Mr Matthew Holmes
Australian Energy Market Operator
GPO Box 2008
Melbourne
VIC 3001
(Lodged electronically)

6 December 2019

AEMO Consultation on FCAS Contribution Factor Procedures and the Market Ancillary Services Specification

Figure 1 Fast FCAS ΔP with narrow deadband response (under frequency event)

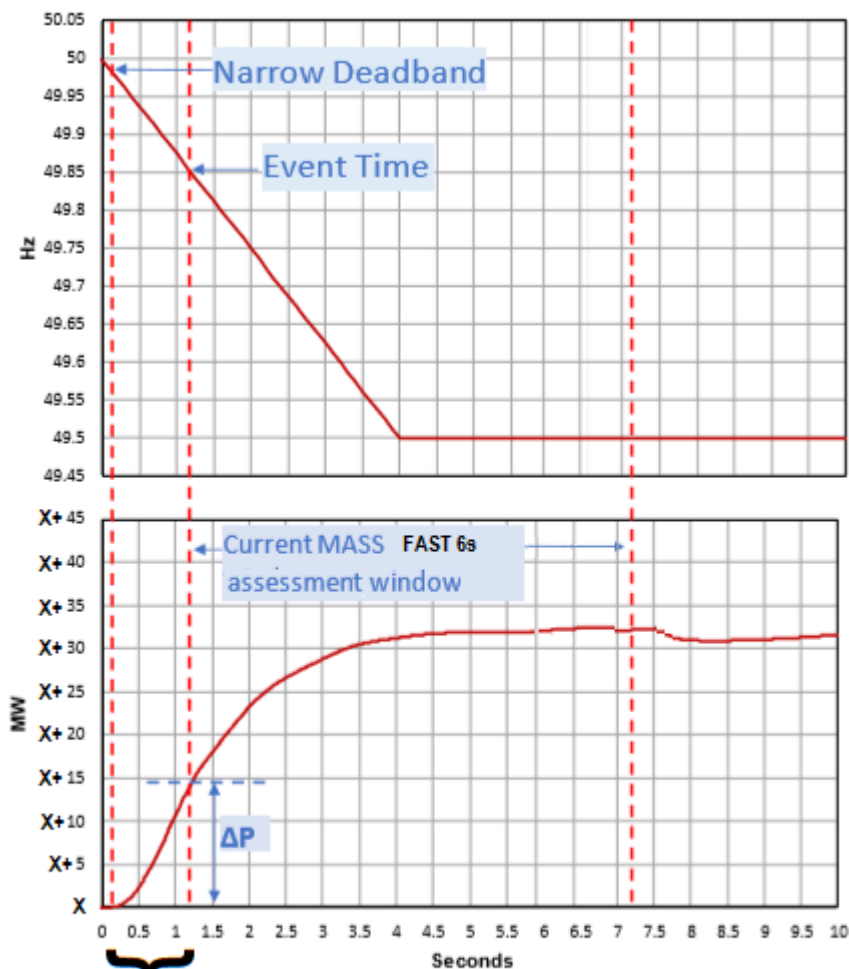
With reference to the MASS issues paper diagram (in which we extend the assessment window to be a full 6s from frequency disturbance time which was not represented in the paper) the assessment window is relabeled as being representative of the FAST response assessment under FB in the FCAS Tool:

Include the response for this period of time in the FAST response assessment calculations

X is representative of the Initial load of relevance to Clause 3.7.1.(a)(v), 4.7.1.(a)(iv) and 5.7.1.(a)(iv) of the MASS.
